UNITED STATES PATENT AND TRADEMARK OFFICE

10/595,714

Office Action Summary	Application No. 10/595,714	Applicant(s) FREEZE, TIMOTHY	
	Examiner JENINE M. PAGAN	Art Unit 4147

DETAILED ACTION

FIG. 9

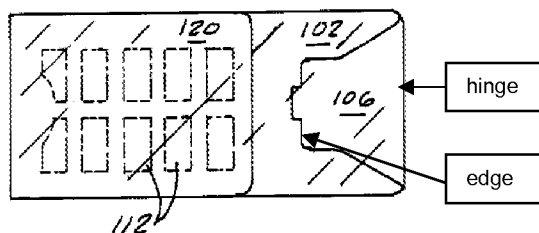
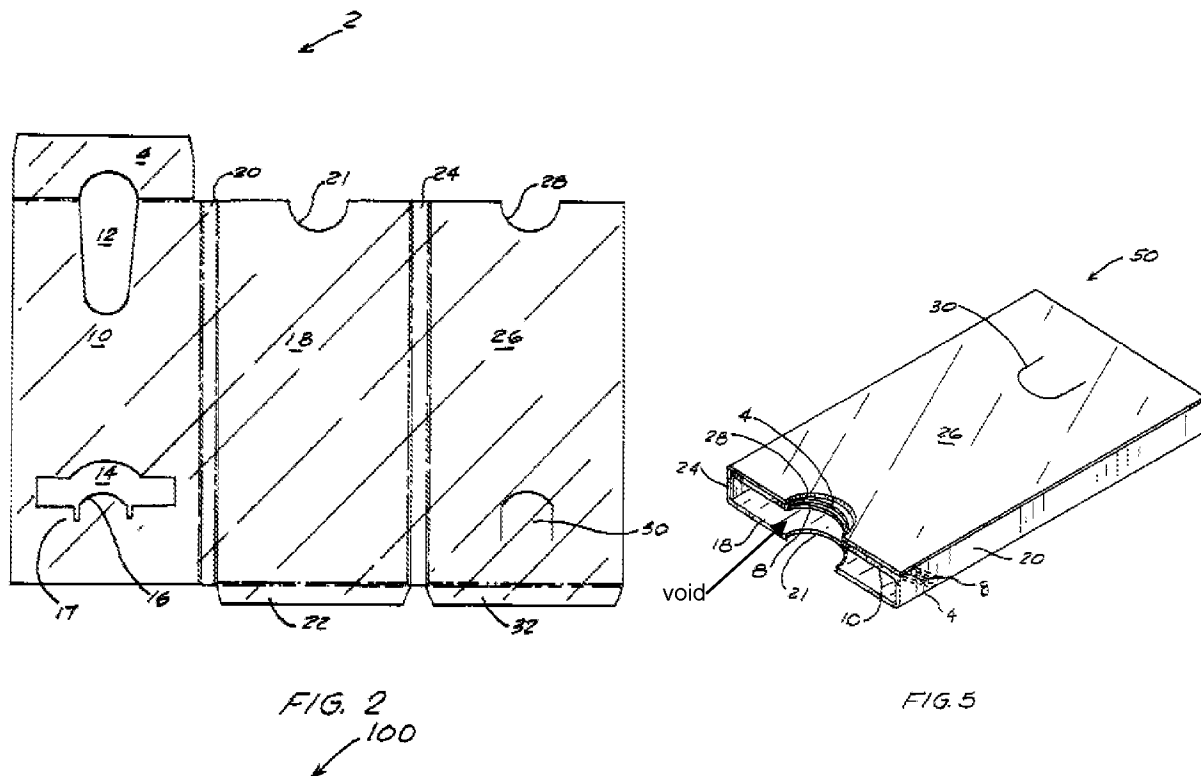
4. Claims 1-2, 4-17, and 20-23 are rejected under 35 U.S.C. 102(b) as being anticipated by Karow (US 6,230,893 B1).
5. In re claim 1, with reference to Figure 2, 5 and 9, Karow '893 discloses:
 - a slide card (100) comprising an engaging element (106) and at least one tray receiving area (120);

- at least one preformed tray (112), attached to said tray receiving area (120), configured to receive and hold at least one portable item (122);
 - an outer sleeve (50) configured to receive said card (100) and attached tray (112), comprising a locking element configured to connect with said engaging element (106) at a locking position; and,

- a release element (30) integral to said outer sleeve (50), configured to disconnect said engaging element (106) from said locking element (Column 4, Lines 61-65)

6. In re claim 2, with reference to Figure 2, 5 and 9, Karow '893 discloses:
- card (100) is constructed of a first material and said tray (112) is constructed of a second material

7. In re claim 4, with reference to Figure 2, 5 and 9, Karow '893 discloses:
- engaging element (106) is positioned on said tray (112)
8. In re claim 5, with reference to Figure 2, 5 and 9, Karow '893 discloses:

- tray (112) comprises at least one receiving recess (110) configured to receive and hold said portable item (122)
9. In re claim 6, with reference to Figure 2, 5 and 9, Karow '893 discloses:

- outer sleeve (50) further comprises an interior aperture configured to connect said engaging element (106) at a stopping position
10. In re claim 7, with reference to Figure 2, 5 and 9, Karow '893 discloses:
